TRANS/WP.29/GRSG/2003/21
25 July 2003

PROPOSAL FOR DRAFT 02 SERIES OF AMENDMENTS TO REGULATION No. 107

(M2 and M3 vehicles)

Transmitted by the expert from the International Organization of
Motor Vehicle Manufacturers (OICA)

"Figure 1 1/

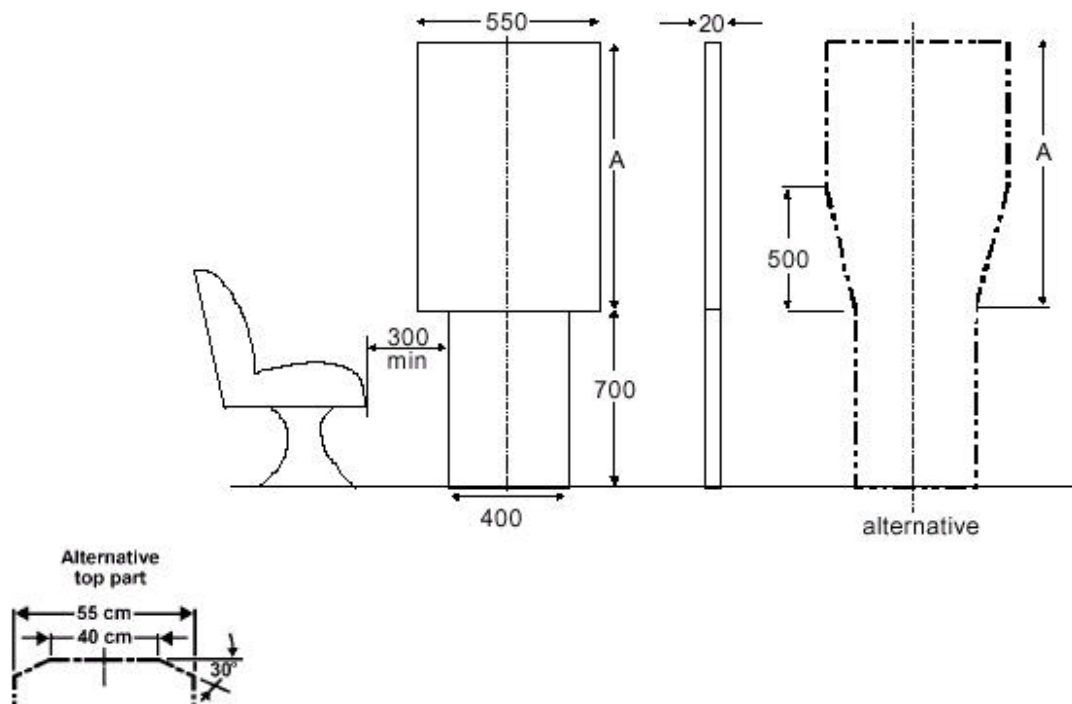
Figure 1, amend to read:

1/ "Alternative top part" diagram should be revised before publication to refer to "550 mm" and "400mm" as appropriate."

Classes I, II and III: A = 1100 mm

Classes A and B: A = 950 mm

Number of passengers	≤ 22 (1)		> 22		
Classes	A	B	I	II	III
Dimension A (mm)	950	700	1100	950	850
Total height of dual panel	1650	1400	1800	1650	1550

"Figure 5

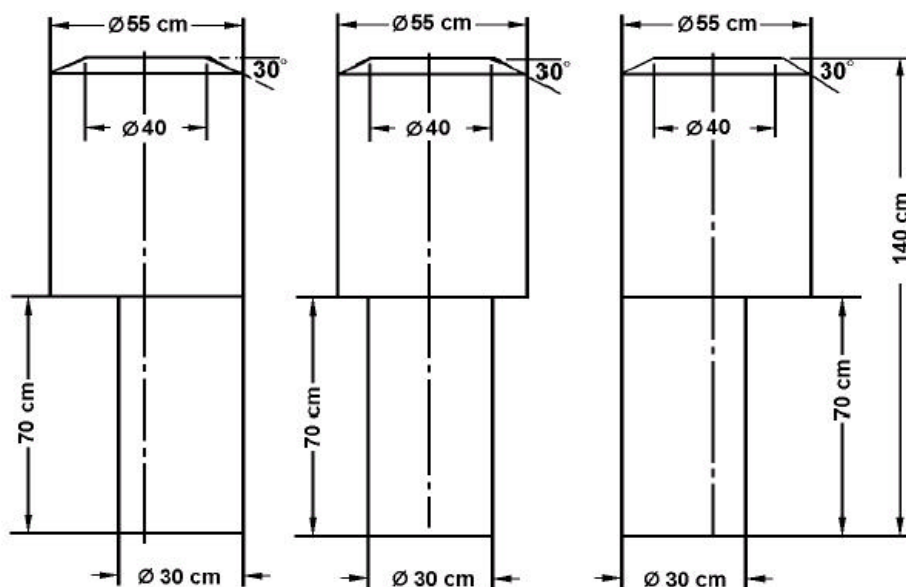
Figure 5, amend to read:

[Editorial note: In final version, units should be changed to mm to align with text]

"Figure 6
GANGWAYS
(see annex 3, paragraph 7.7.5.)

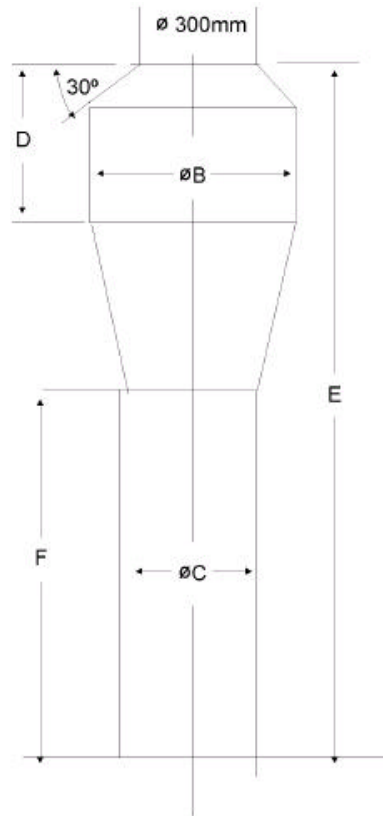
Figure 6, amend to read:

Single deck						
Class	B (mm)	C (mm)	D (mm)	E (mm)	F (mm)	
A	550	350	500 (4/)	1900 (4/)	900	
B	450	300	300	1500	900	
I	550	450 (3/)	500 (4/)	1900 (4/)	900	
II	550	350	500 (4/)	1900 (4/)	900	
III	450	300 (2/)	500 (4/)	1900 (4/)	900	
Double deck						
I	LD	550	450 (3/)	500	1800 (1/)	1020 (1/)
	UD	550	450(3/)	500	1680	900
II	LD	550	350	500	1800 (1/)	1020 (1/)
	UD	550	350	500	1680	900
III	LD	450	300 (2/)	500	1800 (1/)	1 020 (1/)
	UD	450	300 (2/)	500	1800	900

- (1/)** The overall height of the gauging device may be reduced (by reducing the height of the lower cylinder):
- a) from 1800 mm to 1680 mm in any part of the gangway of the lower deck to the rear of a transverse vertical plane situated 1500 mm forward to the centre of the rear axle (foremost rear axle in the case of vehicles with more than one rear axle),

- b) from 1800 mm to 1770 mm in the case of a service door which is situated forward the front axle in any part of the gangway situated between two transverse vertical planes situated 800 mm forwards and behind the centre line of the front axle.

- (2/)** 220mm in the case of laterally movable seats (see paragraph 7.7.5.3).
- (3/)** The diameter of the lower cylinder may be reduced from 450 mm to 400 mm in any part of the gangway to the rear of the most forward of the following two planes:

- (4/)** The height of the upper cylinder and herewith the overall height may be reduced by 100 mm in any part of the gangway to the rear of:
- a) a transverse plane situated 1.5 m forward of the centre line of the rear axle (foremost rear axle in the case of vehicles with more than one rear axle), and
 - b) a transverse vertical plane situated at the rear edge of the service door or of the rearmost service door if there are more than one service door."

"Figure 8

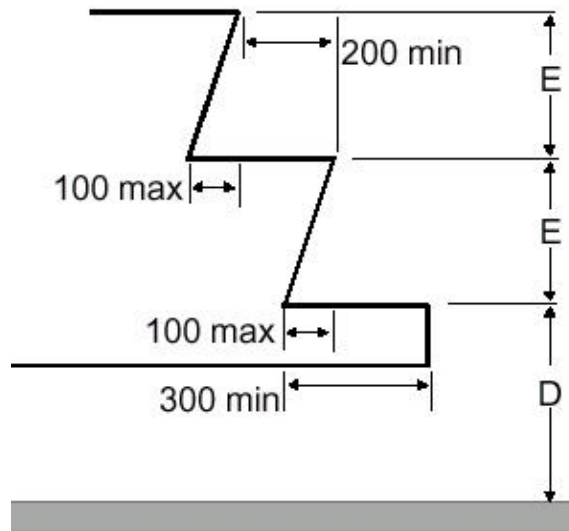
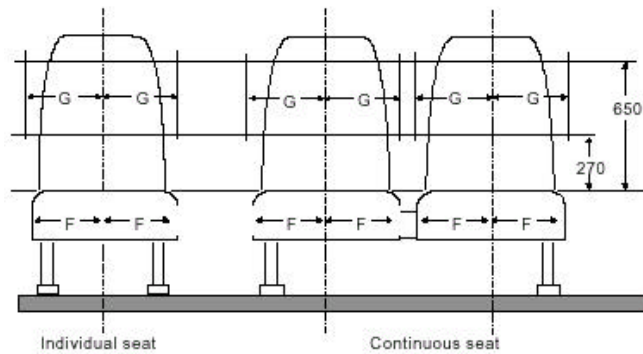
Figure 8, amend to read:

Classes		I & A	II, III and B
First step from ground 'D'	Max. height (mm)	340 (1)	380 (1)(2)(5)
	Min. depth (mm)	300 (*)	
Other steps 'E'	Max. height (mm)	250 (3)	350 (4)
	Min. height (mm)	120	
	Min. depth (mm)	200

- (*) 230 mm for vehicles having a capacity not exceeding 22 passengers.
- (1) 700 mm in the case of an emergency door.
1500 mm in the case of an emergency door in the upper deck of a double deck vehicle.
850 mm maximum in the case of an emergency door in the lower deck of a double-deck vehicle.
- (2) 430 mm in the case of a vehicle with solely mechanical suspension.
- (3) 300 mm in the case of steps at a door behind the rearmost axle.
- (4) 250 mm in gangways for vehicles having a capacity not exceeding 22 passengers.
- (5) For at least one service door; 400 mm for other service doors.

Note: 1. At a double doorway the steps in each half of the access passage shall be treated separately.
2. E need not be the same for each step."

Figure 9A

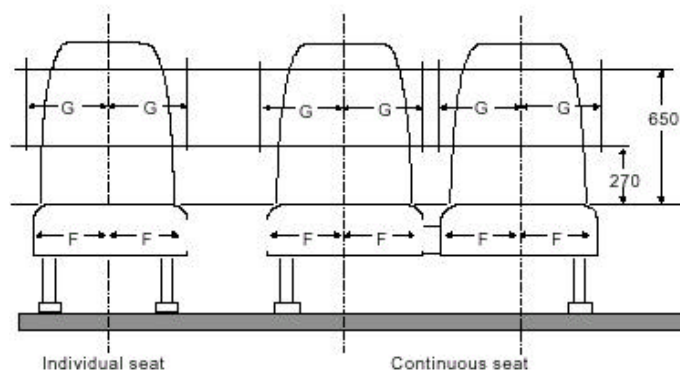
Figures 9 and 9A, amend to read:

G (mm) min	
F (mm) min	Continuous seats	Individual seats
200	200	200

"Figure 15

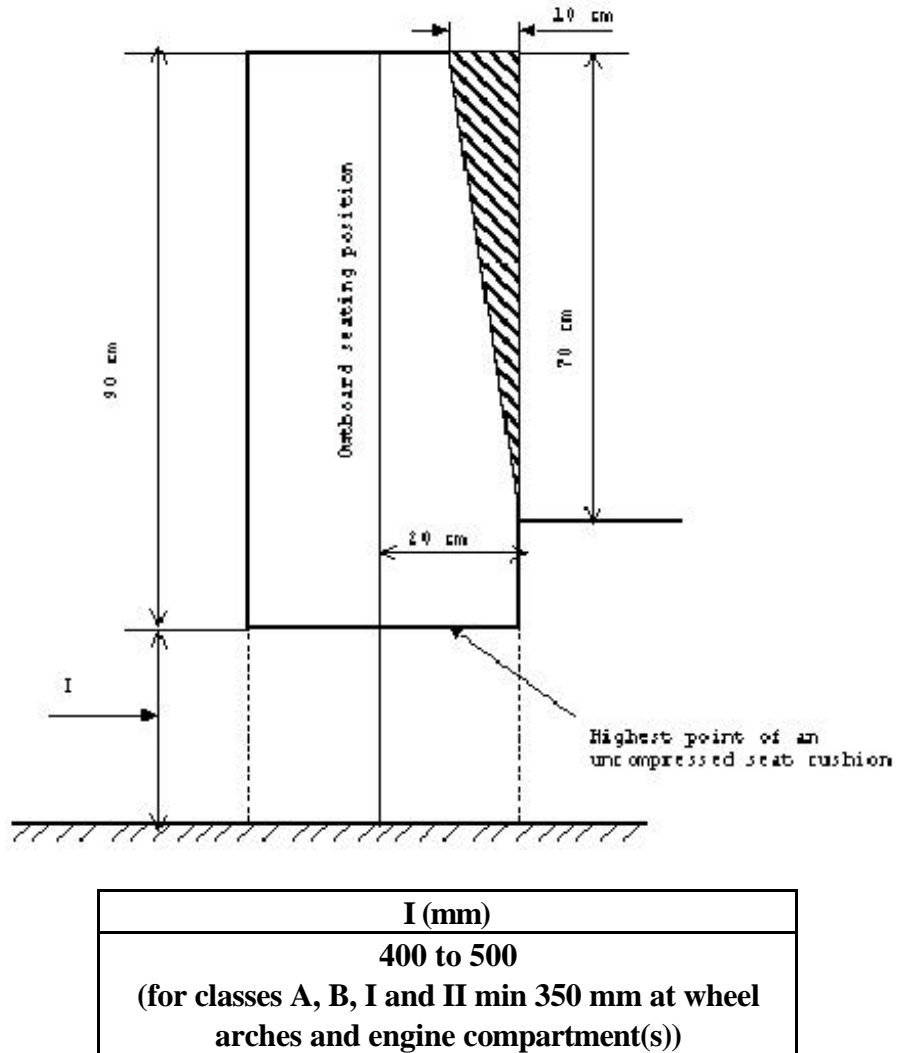
Figure 15, amend to read:

[Editorial note: In final version, dimensions on diagram should be converted to mm]

"Figure 20

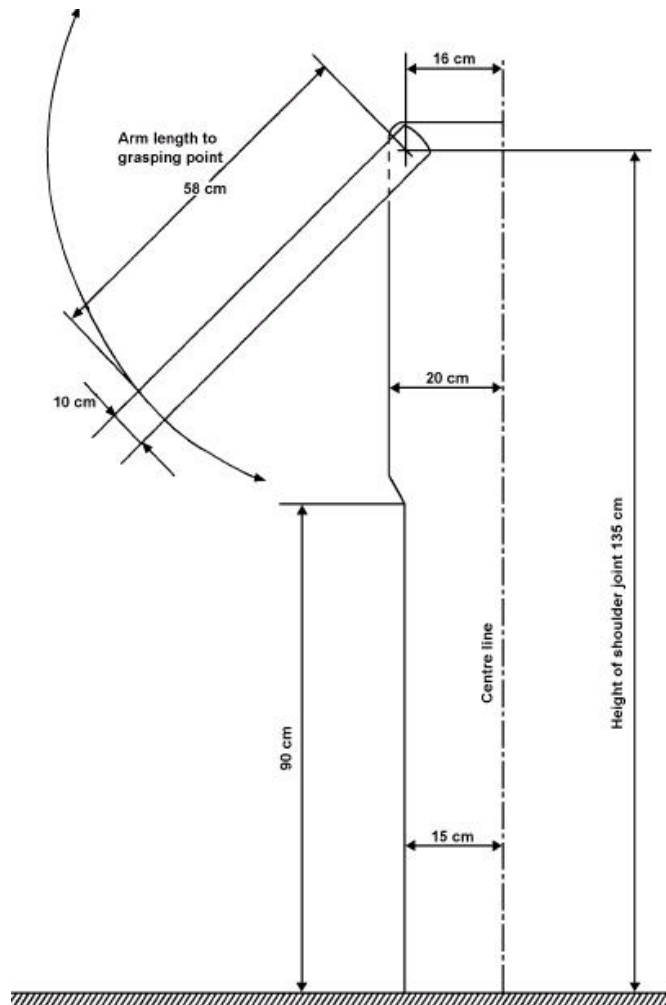
Figure 20, amend to read:

Thickness: 2cm."

Figure 24

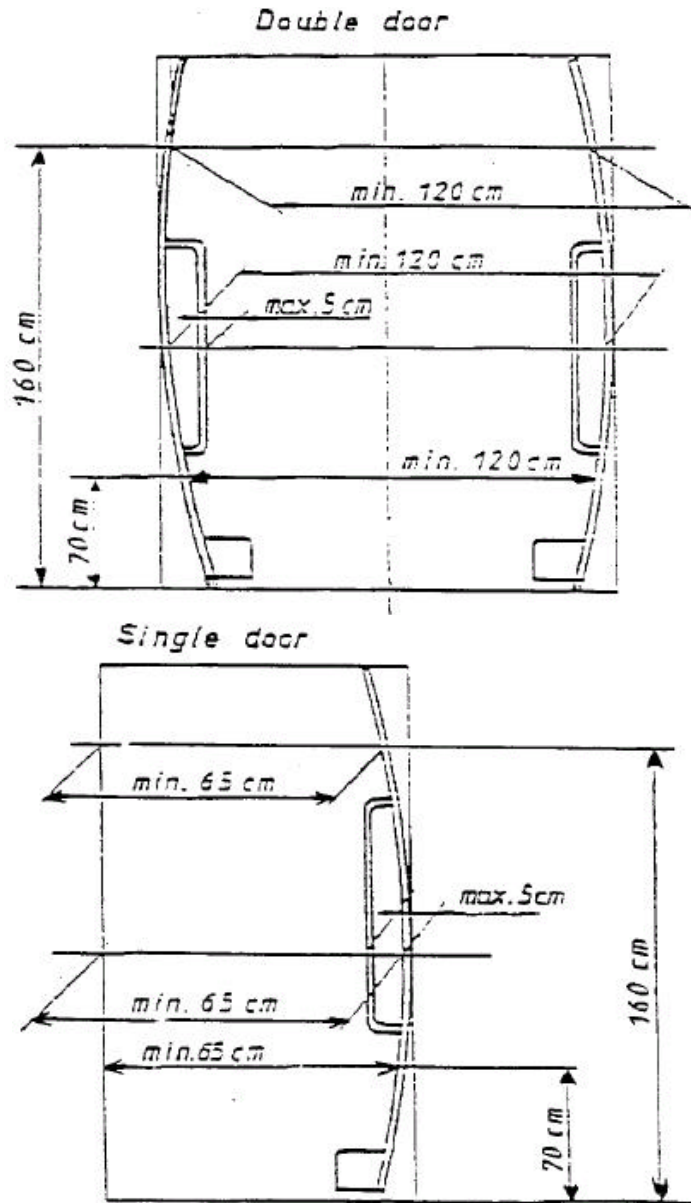
"7.6.3.1. The several kinds of exit shall have the following minimum dimensions **of free access** (see also annex 4, Figure 24):

Insert new figures 24 to 26, to read:

Figure 25

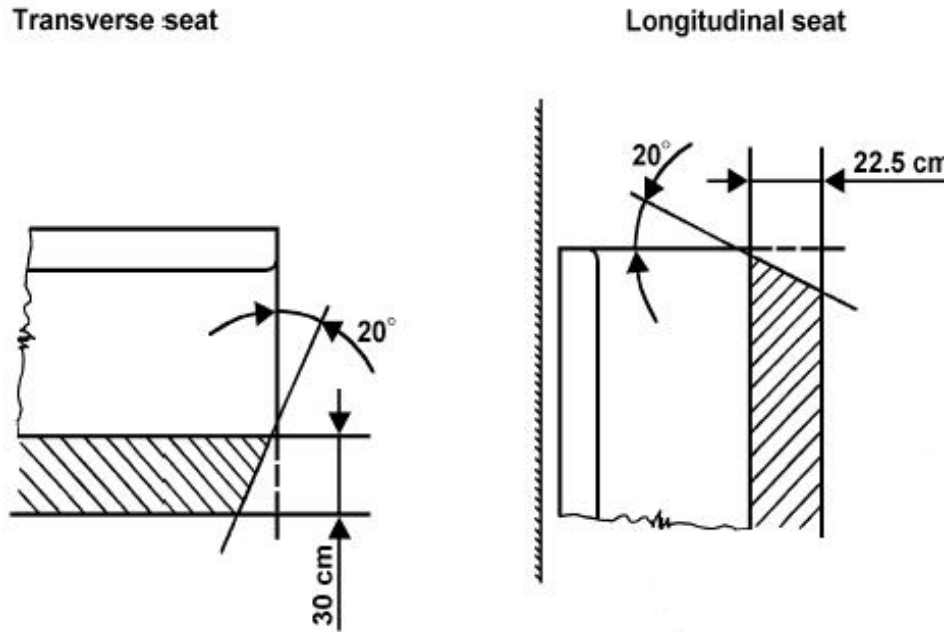
"7.7.1.6. The free passage clearance for this figure shall not include any space extending to 300 mm in front of any uncompressed seat cushion of a forward or rearward facing seat, or 225 mm in the case of seats fitted at wheel arches, and to the height of the top of the seat cushion **(see annex 4, figure 25)**."

Figure 26

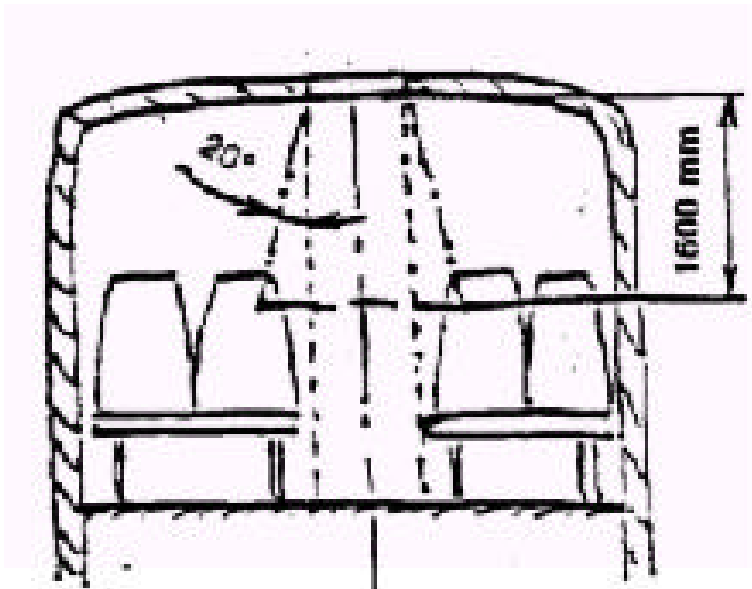
"7.7.4.1.1. Except in the case of Class I **and A** vehicles, at least one escape hatch shall be located such that a four-sided truncated pyramid having a side angle of 20 degrees and a height of 1600 mm touches part of a seat or equivalent support. The axis of the pyramid shall be vertical and its smaller section shall contact the aperture area of the escape hatch. Supports may be foldable or movable provided they can be locked in their position of use. This position shall be taken for verification."
